FORM APPROVED
OMB No. 1004-0137
Expires July 31, 2010**SUNDRY NOTICES AND REPORTS ON WELLS**
*Do not use this form for proposals to drill or to re-enter an abandoned well. Use Form 3160-3 (APD) for such proposals.***SUBMIT IN TRIPLICATE - Other instructions on page 2**

SKELLY UNIT 81

30-015-05371

**Permanent Abandonment of Federal Wells
Conditions of Approval (LPC Habitat)**

Well Name	Skelly Unit	Well No.	#81
Field		API #:	30-015-05371
County	Eddy	Prop #:	
State	New Mexico	Zone:	Grayburg Jackson
Spud Date	6/2/1960		810' FSL 660' FEL
GL	8/6/1910		Sec 08 T25S R29E
KB	3875

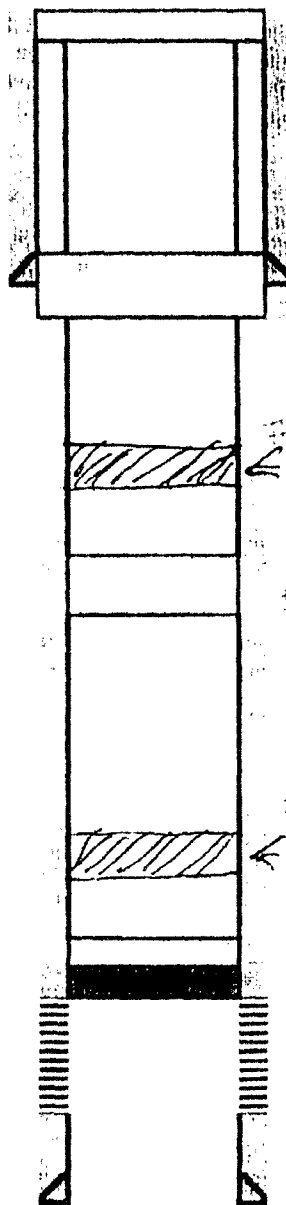
200'
Perf & Sqz 50 sx cmt @ 850-720'. WOC & Tag (Shoe & T/Salt)

← ADD A PLUG @ 1485' - TO 1385' (TOP OF CMT) WOC & TAG

← ADD A PLUG @ 2900' - TO 2800' (POVERS QUEEN)
